## Determination 2019/027

# Regarding building work compliance at 302 Kennedys Bush Road, Christchurch with Building Code Clause E1 Surface water, and grant of a building consent and code compliance certificate for this work

**Figure 1: Site layout and flow direction of surface water (from the experts' report)**

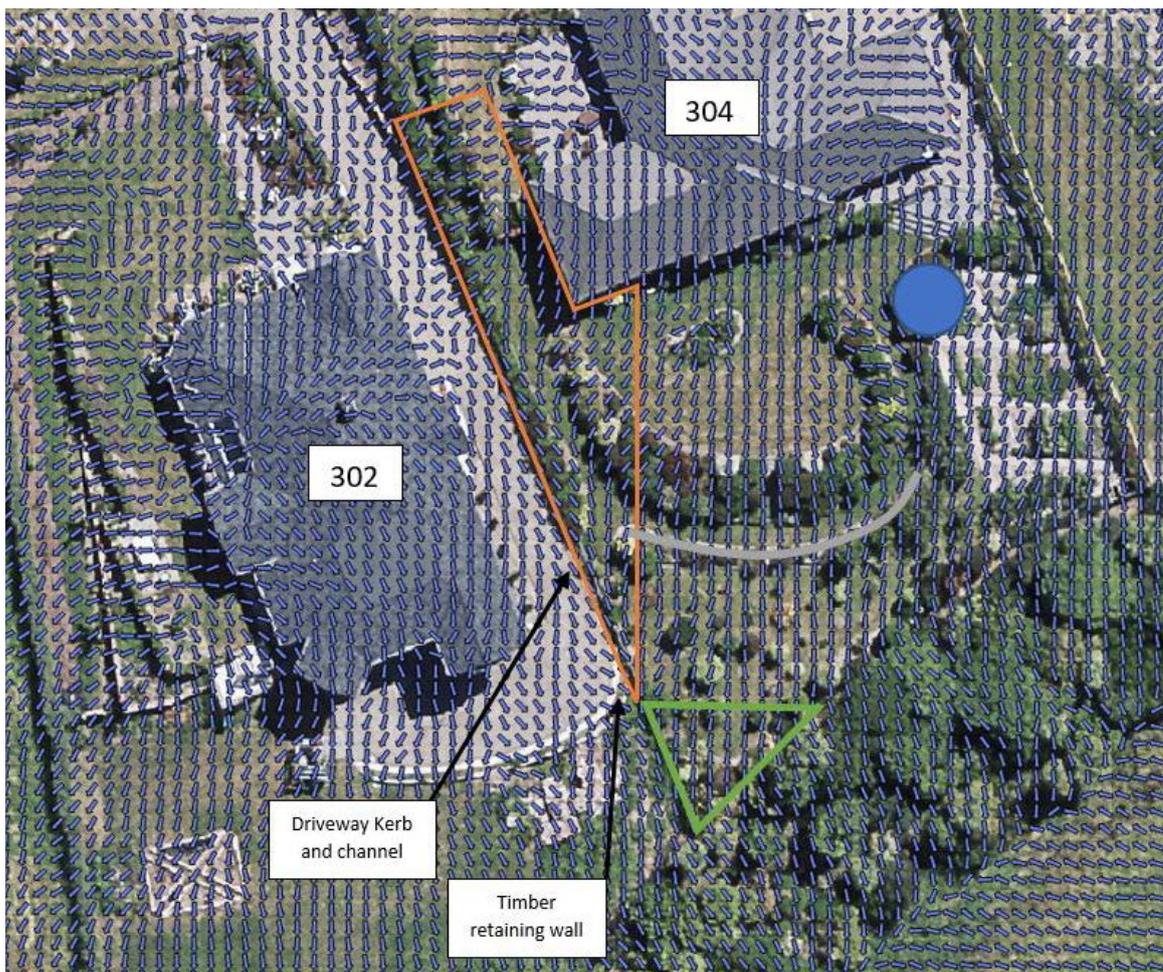
5.2 In their report the experts said their review of the material and onsite observations indicated that the overland flow concentrated along the boundary between No. 304 and No. 302 by No. 302 was likely to cause a nuisance and damage to No. 304.

5.3 The experts said the flow rates predicted for a 1:10 year storm event, concentrated along the steep flow path at the shared boundary between Nos 302 and 304, were likely to cause scour and erosion damage in the southwestern corner of the applicant's property. Accordingly, in their view the neighbour's driveway development works did not comply with Clause E1.3.1.

This is because the driveway prevents the natural overland flow of water from [No.] 304 crossing the boundary in the manner it did prior to development of the subdivision and leads to a concentration of these flows at the southwest corner of [No.] 304, where scour and erosion of the land is likely to occur.

5.4 The experts said the owner's construction of a driveway kerb and the subsequent backfilling of the area between this kerb and the shared boundary had collected and concentrated the overland flow, which was then disposed of back onto the neighbour's property.

- 6.2.5 The applicant also commented on water flow and on what she said were raised levels at other areas of the owner's property, mostly from landscaping. She was concerned that not all the conflicting areas of the flow direction identified on the experts' diagram had been considered.
